Title: NuScale Subcommittee Open Session

Date: 05-15-18

UNITED STATES NUCLEAR REGULATORY COMMISSION'S
ADVISORY COMMITTEE ON REACTOR SAFEGUARDS

8 So this is just a quick overview of what's
9 in the topical report. So the topical report is
10 seeking approval to use CMS5 code suite from Studsvik
11 for physics design and analysis for the NuScale
12 reactor.

Core Radial Reflector

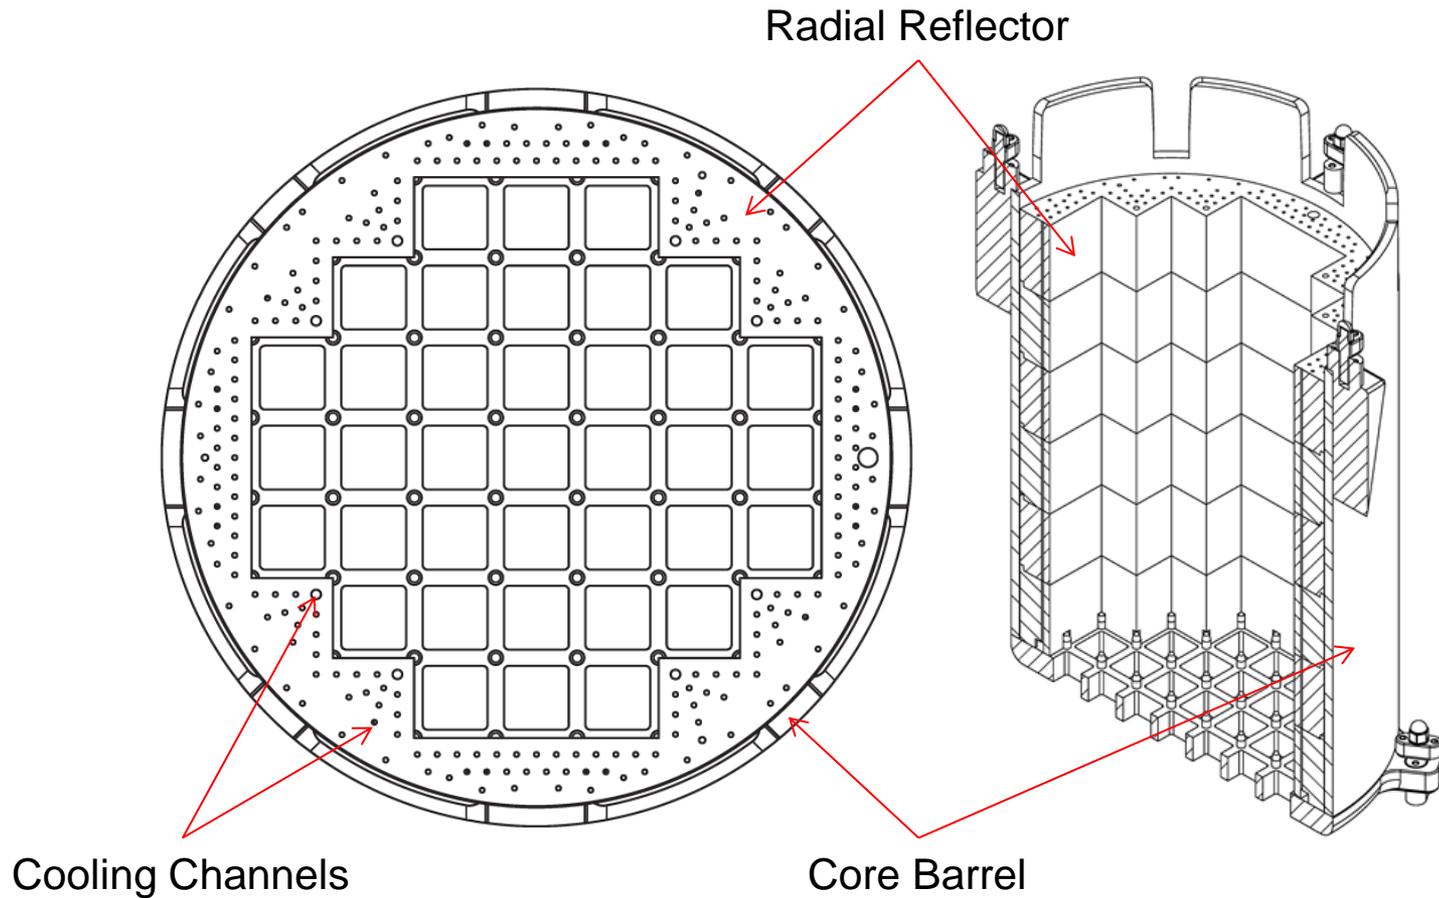
21 MR. KIRBY: So as you can see in this
22 slide, it's a depiction of the heavy reflector around
23 the core. That reflector contains cooling channels to
24 remove the heat generated by the gamma radiation. And
25 the heavy reflector for NuScale was designed to

3 As can be seen in the figure, the
4 reflector thickness varies around the core and ranges
5 from about 10 centimeters to about 30 centimeter.
